# HOUNSLOW CYCLING

## Hounslow to Brentford Walking and Cycling Changes

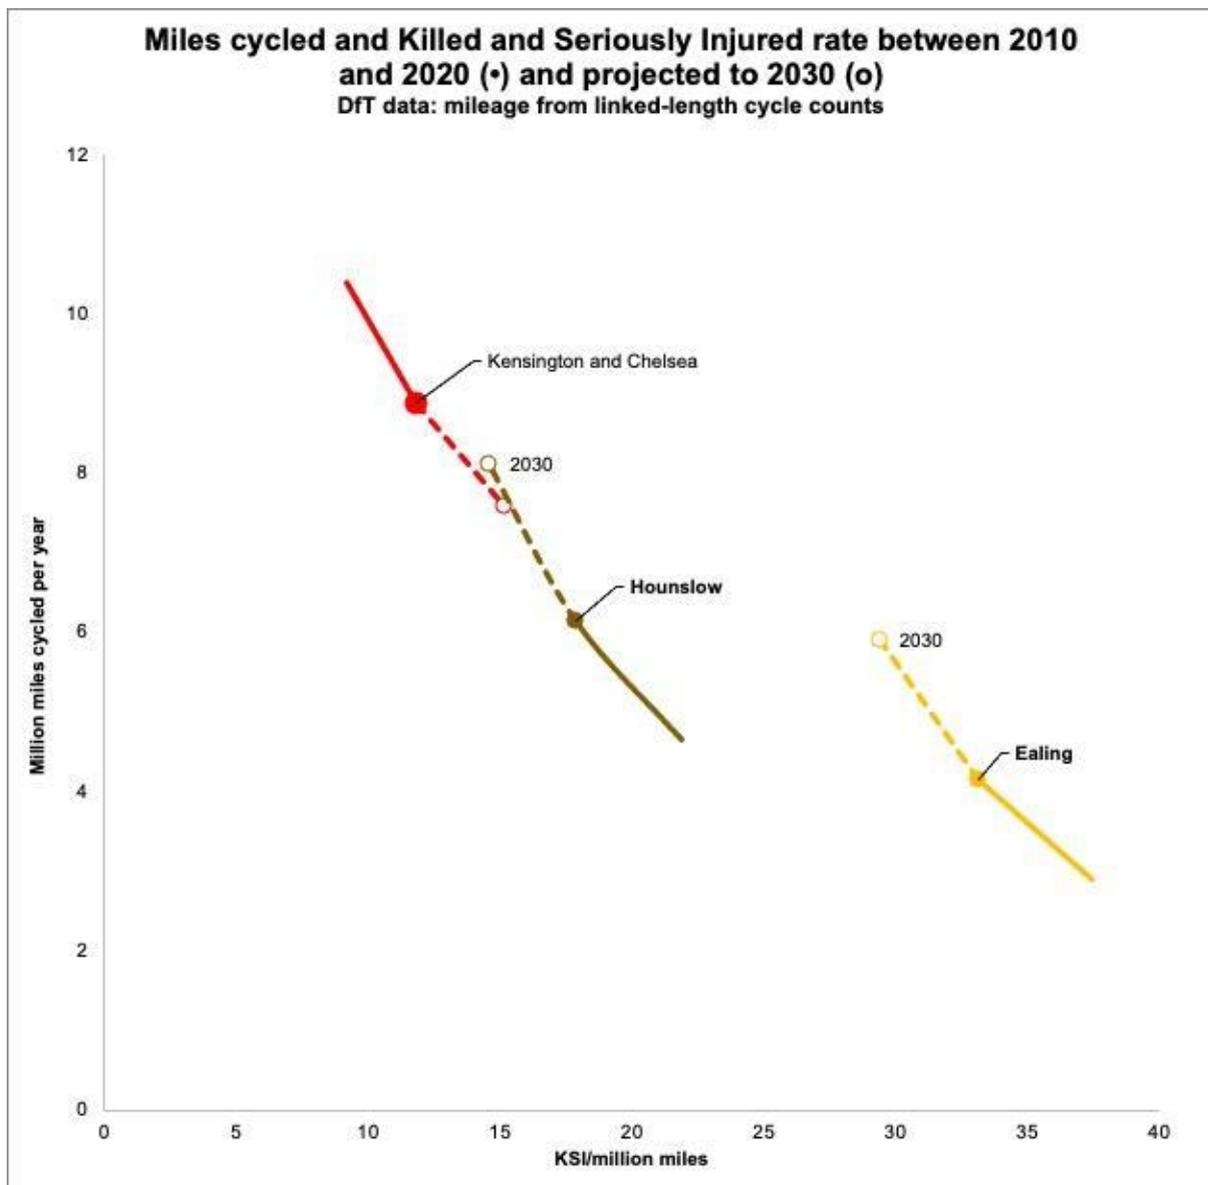
We prefer a vertical profile aligned consistently to either the footway (with bevelled separation) or the main carriageway (with kerb separation). A kerbless mid profile uses space efficiently but is too easily blocked by vans parked or loading. Switchbacks are uncomfortable for riders.
